**NOTICE OF DECISION**

**CONDITIONAL USE PERMIT #186-24-000117-PLNG**

**REQUEST:** Type II conditional use application for a coffee kiosk in a commercial zone.

**CONDITIONAL USE PERMIT #186-24-000117-PLNG**

**SITE PLAN (applicant supplied)**

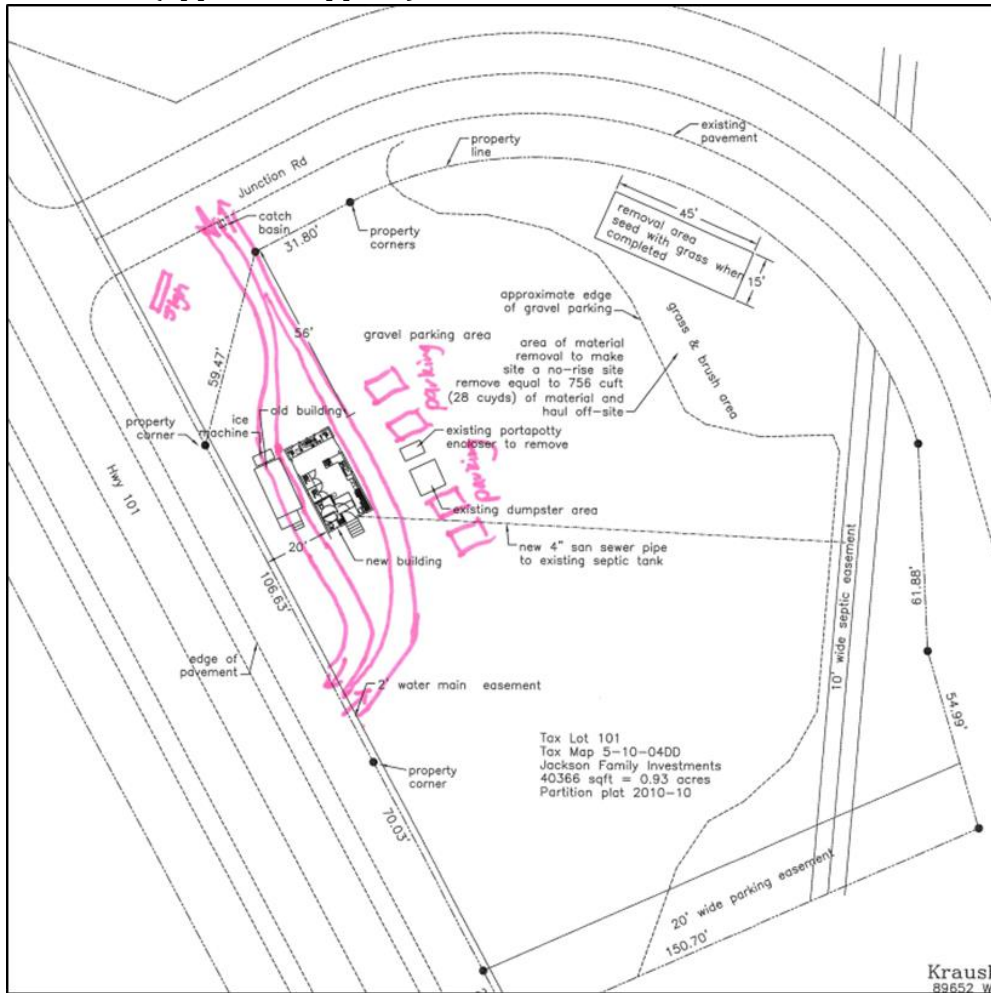
**STAFF FINDINGS AND CONCLUSION:** The application included a site plan for the placement of a permeant coffee kiosk (see Exhibit 1).  
**This section will be satisfied with conditions of approval (Condition of Approval 1a).**

**Staff Finding:** The applicants are proposing a 15' by 28' (420 square feet) coffee kiosk. Following the adoption of Ordinance 23-07, Section 3.0060(2) includes a requirement for coffee kiosk at two spaces. In total four parking spaces are shown on the applicant's site plan. In total, the applicants shall be required to show a total of two parking spaces on the final site plan/parking plan when submitting for a Development Permit.

(D) The applicant's site plan doesn't include proposed parking abutting a public right-of-way; HWY 101 or Junction Road. As such, the applicant is not required to provide screening on the front property line. If the applicant would like to have parking abutting a public right-of-way, a wall or screen planting shall be required to be provided sufficient screening to parking facilities but without causing encroachment into vision clearance areas. **This criterion is satisfied.**

- a. A final site plan, including the size and location of all structures and sufficient information to demonstrate all development standards and conditions of approval will be satisfied.

- c. Per Section 3.0080 the applicants shall create an Off-Street Parking Plan. An Off-Street Parking Plan can be shown on the site plan or as a separate parking plan. Additionally, the applicants shall have the required parking spaces available prior to obtaining final building permits and before opening the coffee stand to customers.
